BAW-10120A

COMPARISON OF CORE PHYSICS CALCULATIONS
WITH MEASUREMENTS

SUBJECT: EVALUATION OF BAW-10120P

SUBJECT: REVIEW OF TOPICAL REPORT BAW-10120

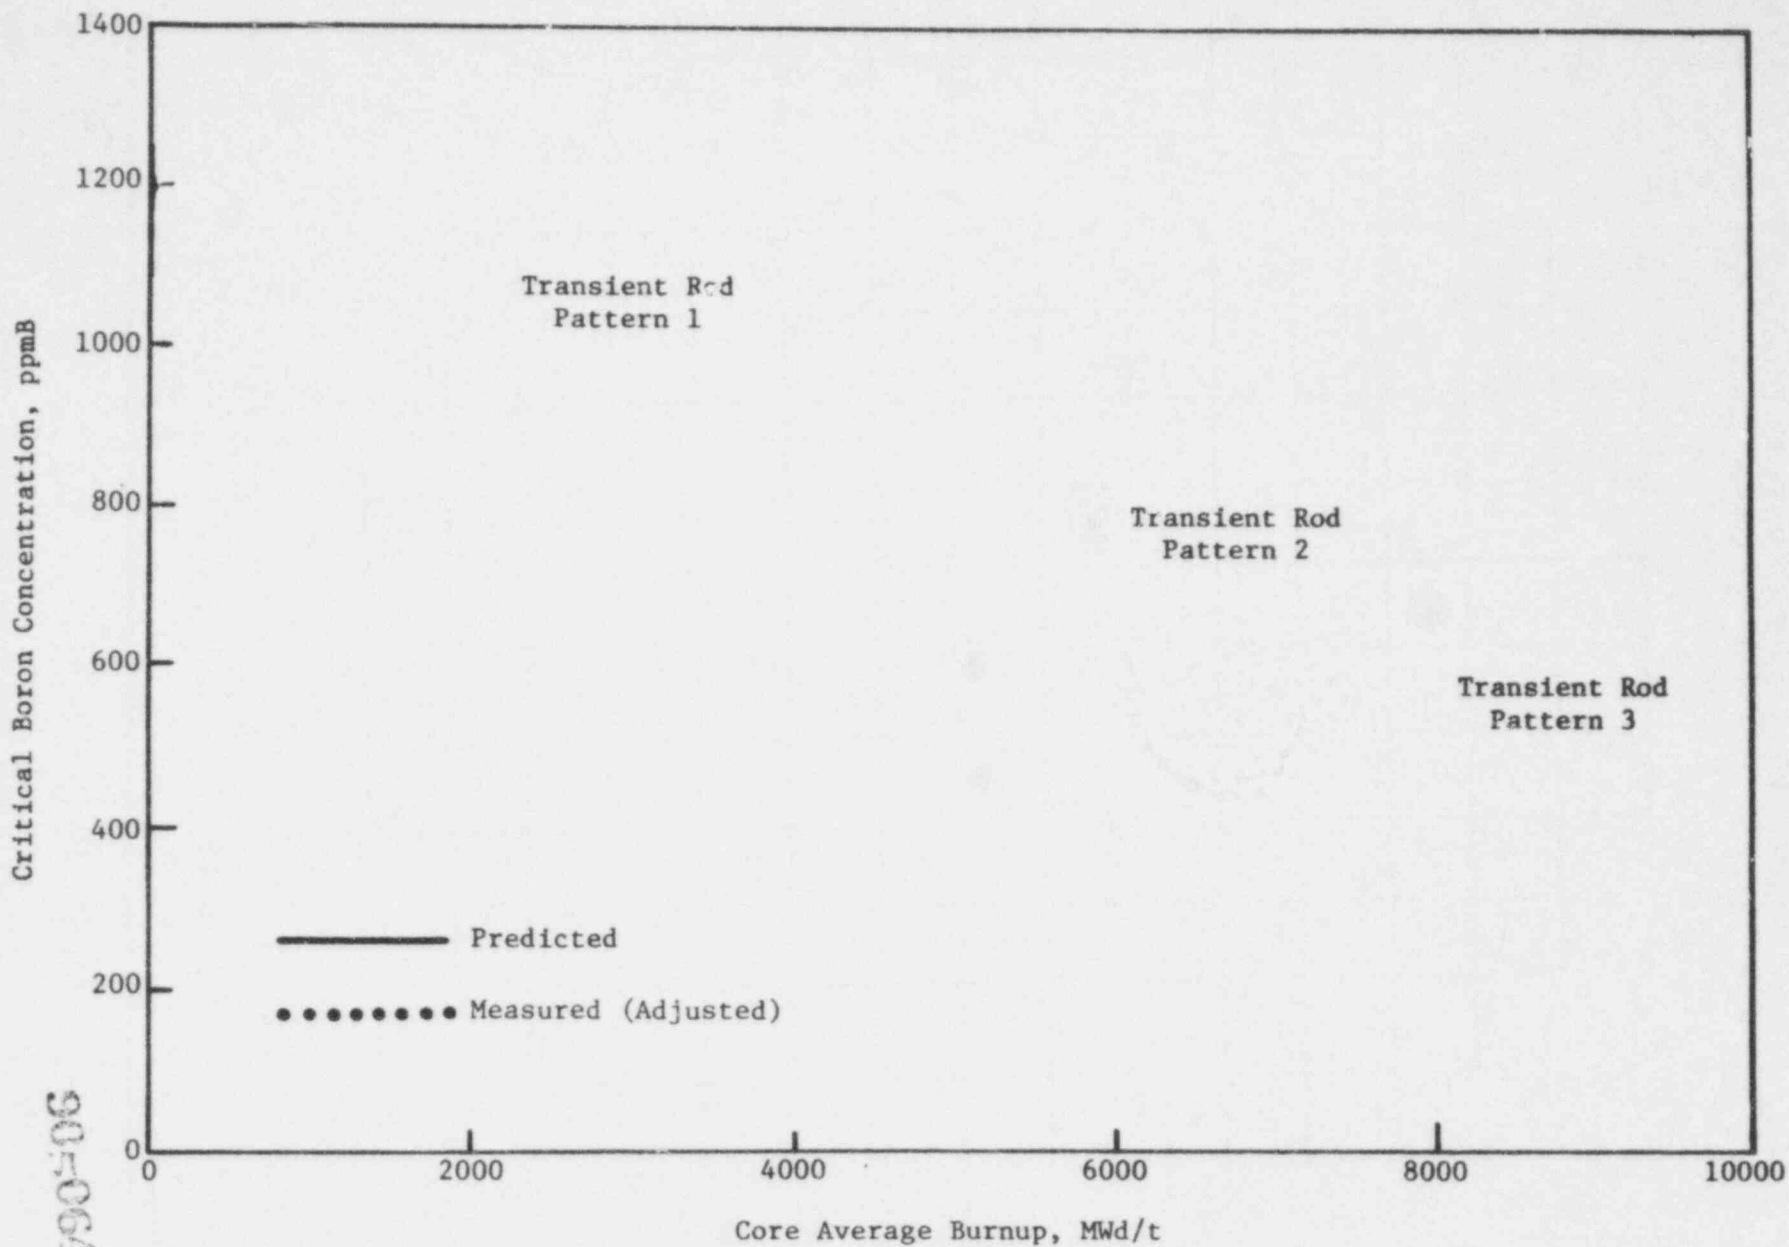
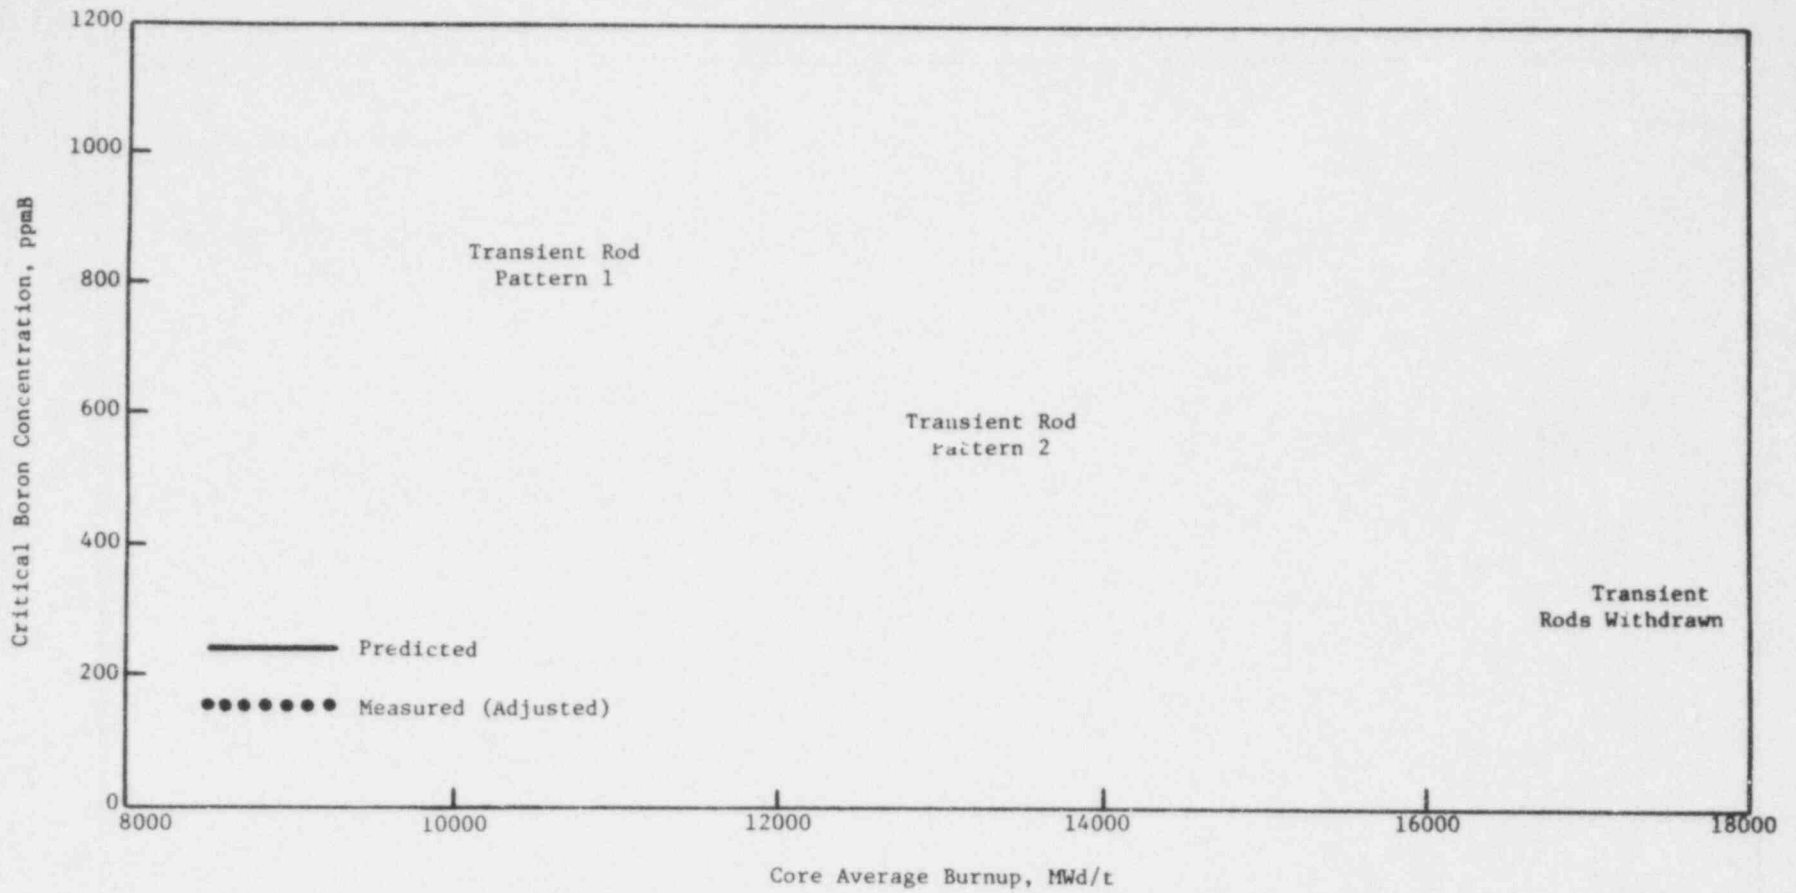
Calculational bias is taken into account for critical boron concentrations and other quantities. Please provide a summary table of such biases.

Standard reactivity corrections which account for reactivity effects due to such known phenomena as nonuniform axial burnup and provide an overall normalization of the model to operating plant data have been included in the predicted critical boron concentrations at power shown in Figures 4-2 thru 4-7.

Figures 4-2, 4-3 - never had LBP - no correction.
